INNER WEST

DEVELOPMENT ASSESSMENT REPORT

Application No.	DA/2022/0193
Address	322 Canterbury Road HURLSTONE PARK NSW 2193
Proposal	Demolition of the existing dwellings on the site and construction of a three storey childcare centre
Date of Lodgement	05 May 2022
Applicant	ArtMade Architects
Owner	Dunkirk Property Development Pty Ltd
Number of Submissions	Initial: 26
Value of works	\$1,920,000.00
Reason for determination at Planning Panel	Number of submissions
Main Issues	Contamination, traffic impacts on Canterbury Road, air quality, design
Recommendation	Refusal
Attachment A	Reasons for refusal
Attachment B	Plans of proposed development
Attachment C	Plan of Management
Attachment D	Conditions in the event of approval.

Figure 2: Map 2 from Chapter D of DCP.

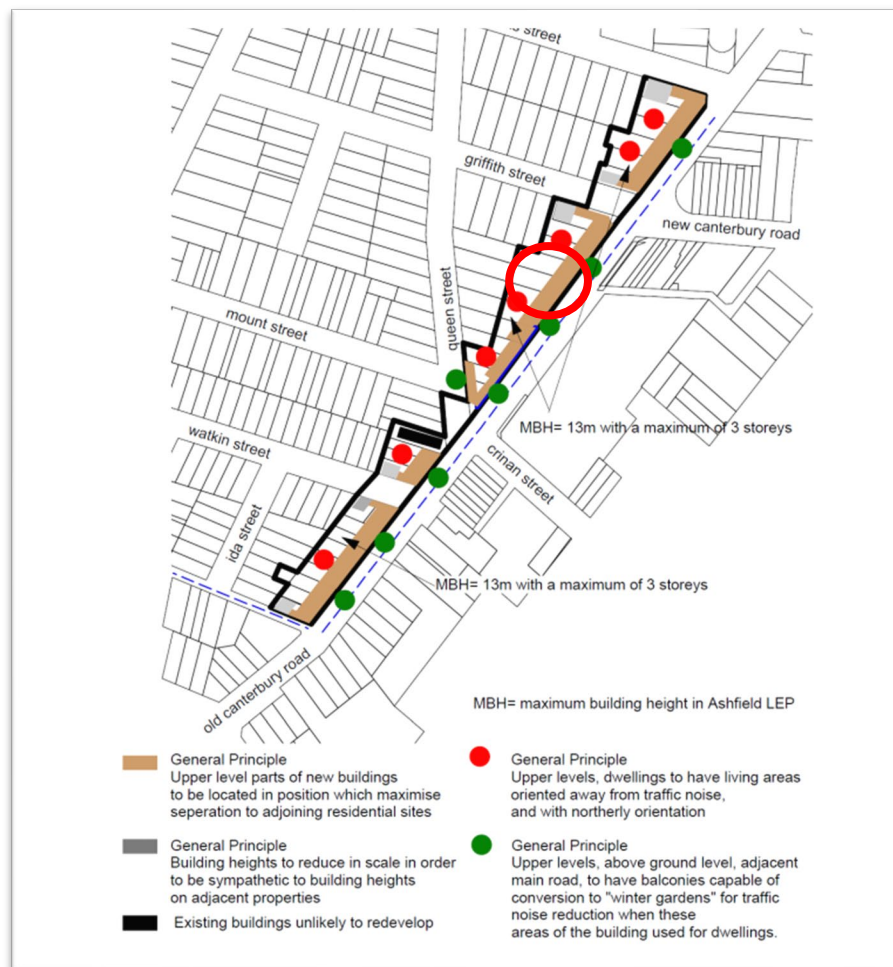
The proposal has been designed generally in accordance with Map 2 in Part 7 Chapter D of the DCP (see Figure 2 below) in that it is 3-storeys in height, has its massing located towards Canterbury Road, maintains substantial separation to the low-scale residential uses at the rear and has nil side setbacks.

The proposal results in a variation to clause DS4.5 of the DCP, which requires a 3m wide deep landscaped buffer zone to be included along the rear boundary adjacent to the low-density residential dwellings to the west. In this instance the proposed variation is not recommended for support as it does not ensure sufficient room for on-site replacement tree planting as requested by Council's Urban Forests Team.
